Meeting Date: Thursday 9 September 2021
Location: Meeting held remotely
Time: 5.00pm

3 LDA2021/0061 60 Balaclava Road, Eastwood

Demolition of existing dwelling and construction of 2 storey boarding house with 12 boarding rooms for 15 lodgers and 6 parking spaces in a basement that is partially above ground at the rear.

City of Ryde Local Planning Panel Report

Figure 5: 3D rendering - initial proposal (as lodged) viewed from rear yard and elevated from the south and birds eye view of the proposal as viewed from Balaclava Road.

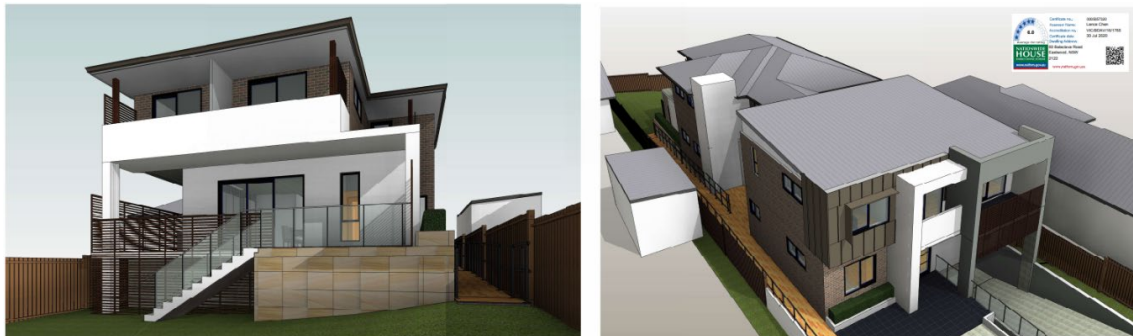
- The elongated design with irregular shaped floor plans results in an unnecessarily complex roof form, with two incongruous roof forms "attached" by a narrow-pitched roof. The complex pattern of roof forms, irregular floor plates, emphasis provided to the lift shaft, irregular window shapes and mix of building materials, combined with the lack of landscaping along the south western boundary will provide an unacceptable presentation to the public domain.

Figure 7:Basement layout - amended proposal

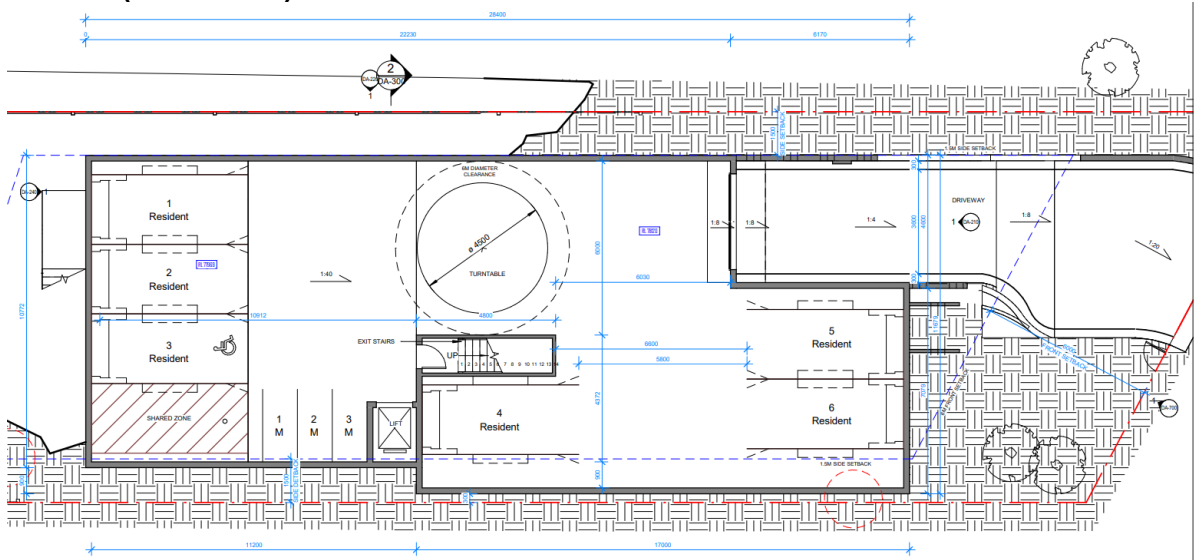
- *Swept path analyses demonstrating forward entry and exit from the site is required for the following car spaces identified as 4, 5, and 6. The swept paths only show entry into the space; the exit manoeuvre is required to be demonstrated.*

- *The access ramp to the basement is designed as a one-way aisle. Due to the low traffic volumes generated from the development; this is generally acceptable. A traffic management system (such as the use of signals) should be utilised provided sufficient area is allocated to accommodate a waiting bay. The locations of traffic signals and waiting bays are to be shown on plan.*

Comment: The Traffic Report has revised both the entry and exit swept path analysis for spaces 3,4,5 & 6. Each space is considered:

Comment: The revised Traffic report has detailed an internal traffic control systems however not nominated a waiting bay in the garage area. This could readily be provided between the turntable and space 1 and could be addressed by condition.

Figure 8: Ground floor - amended proposal

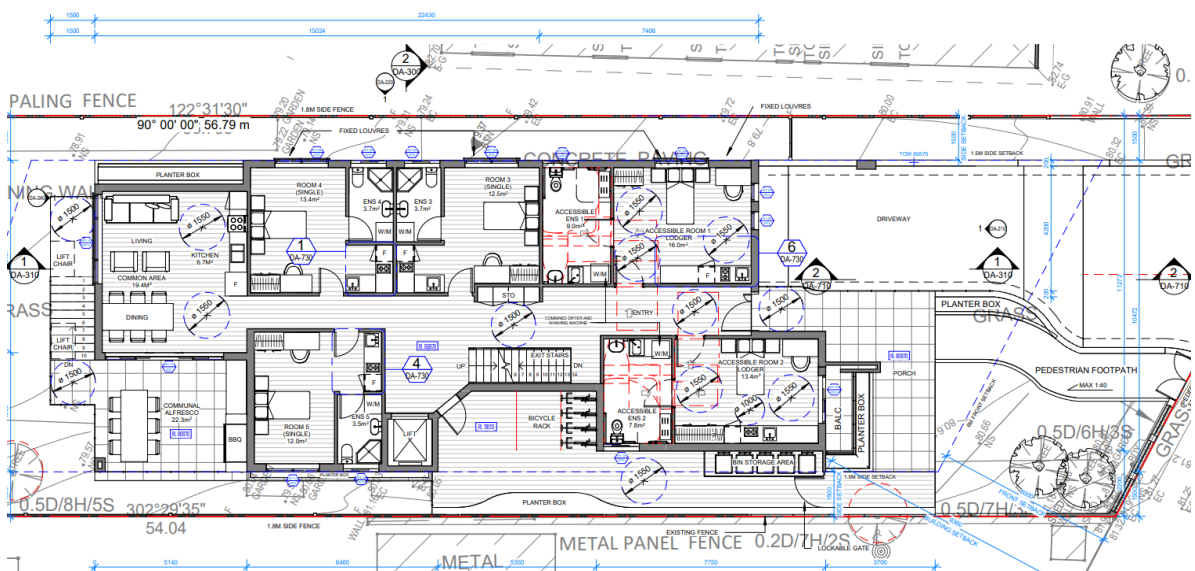
- Layout of communal kitchen in the architectural plans shows cupboards, a cook top and bench space, but no oven, fridge or sink. Provision should be made for bench space, an oven, a sink and a fridge, along with cupboard space.
